UNITED STATES
DEPARTMENT OF THE INTERIOR
BUREAU OF LAND MANAGEMENTFORM APPROVED
OMB NO. 1004-0137
Expires: January 31, 2018**SUNDRY NOTICES AND REPORTS ON WELLS**
*Do not use this form for proposals to drill or to re-enter an abandoned well. Use form 3160-3 (APD) for such proposals.*5. Lease Serial No.
NMNM118108

1. Type of Well <input type="checkbox"/> Oil Well <input checked="" type="checkbox"/> Gas Well <input type="checkbox"/> Other		8. Well Name and No. HH SO 8 P2 13H
2. Name of Operator CHEVRON U.S.A. INC. Contact: DORIAN K. FUENTES E-Mail: djvo@chevron.com		9. API Well No. 30-015-43933
3a. Address 6301 DEAUVILLE BLVD MIDLAND, TX 79706	3b. Phone No. (include area code) Ph: 432-687-7631	10. Field and Pool or Exploratory Area PURPLE SAGE; WOLFCAMP (GAS)
4. Location of Well (Footage, Sec., T., R., M., or Survey Description) Sec 17 T26S R27E Mer NMP NWNW 305FNL 960FWL 32.048937 N Lat, 104.217787 W Lon		11. County or Parish, State EDDY COUNTY, NM

Chevron respectfully requests the ability to change the BOPE rating for the selected well from a 10M system to a 5M system. The max mud weight at 10500' for the pore pressure is a 13.0 ppg. The MASP under these assumptions will be 4788

20 X 13 3/8 X 9 5/8 X 5 1/2

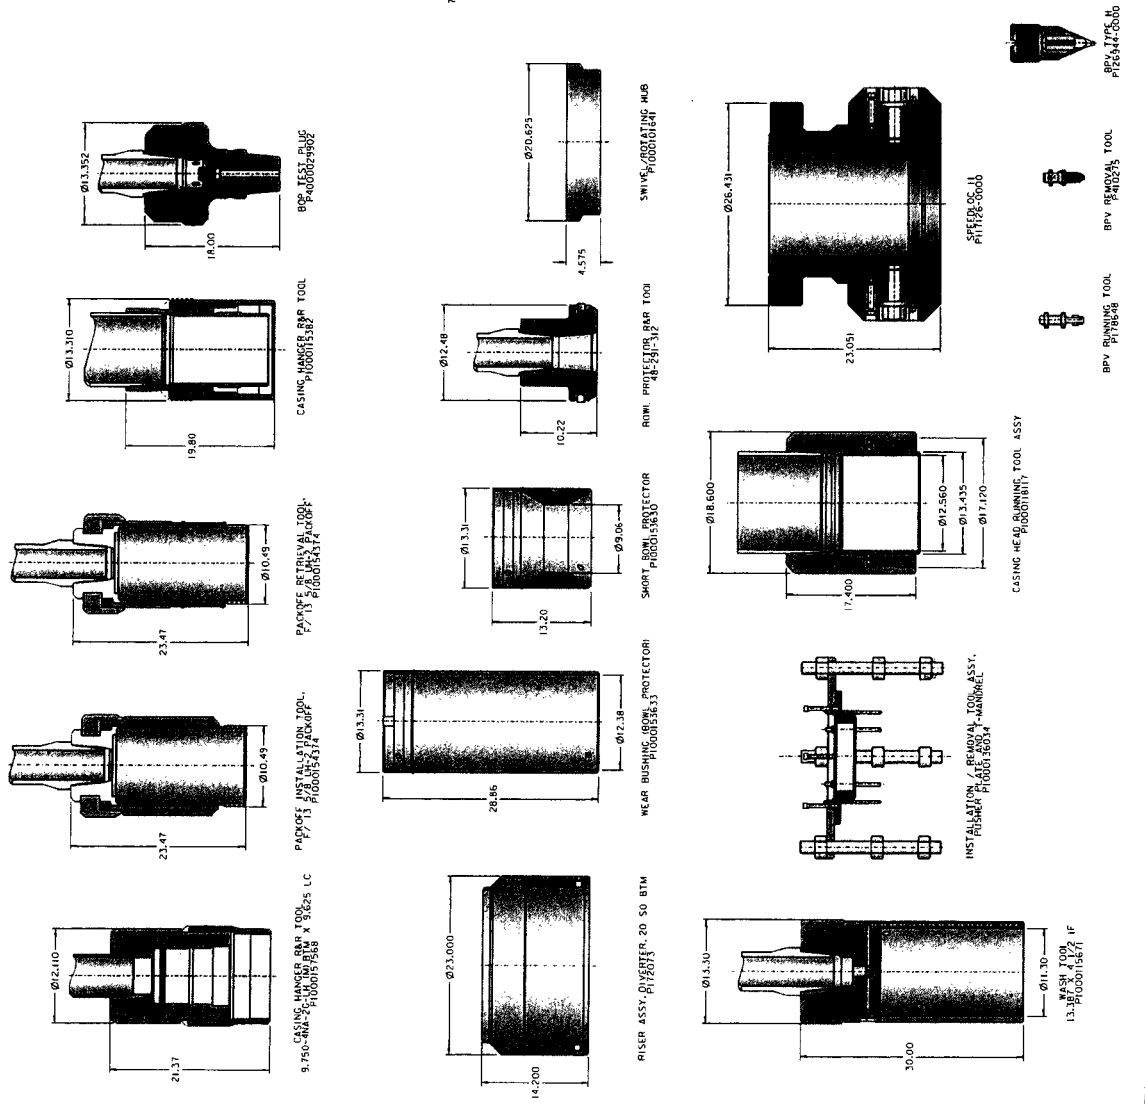
Chevron requests a variance to use a FMC Technologies UH-2 Multibowl wellhead which will be run through the rig floor on surface casing. BOPE will be nipped up and tested after cementing surface casing. Subsequent tests will be performed as needed, not to exceed 30 days. The wellhead from FMC Technologies and BOP test information will be provided in a subsequent report at the end of the well. Please refer to the attached wellhead schematic.

Operator has proposed a multi-bowl wellhead assembly. This assembly will only be tested when installed on the surface casing. Minimum working pressure of the blowout preventer (BOP) and related equipment (BOPE) required for drilling below the surface casing shoe shall be 5000 (5M) psi.

- a. Wellhead shall be installed by manufacturer's representatives, submit documentation with subsequent sundry.**
- b. If the welding is performed by a third party, the manufacturer's representative shall monitor the temperature to verify that it does not exceed the maximum temperature of the seal.**
- c. Manufacturer representative shall install the test plug for the initial BOP test.**
- d. Operator shall perform the intermediate casing integrity test to 70% of the casing burst. This will test the multi-bowl seals.**
- e. If the cement does not circulate and one inch operations would have been possible with a standard wellhead, the well head shall be cut off, cementing operations performed and another wellhead installed.**
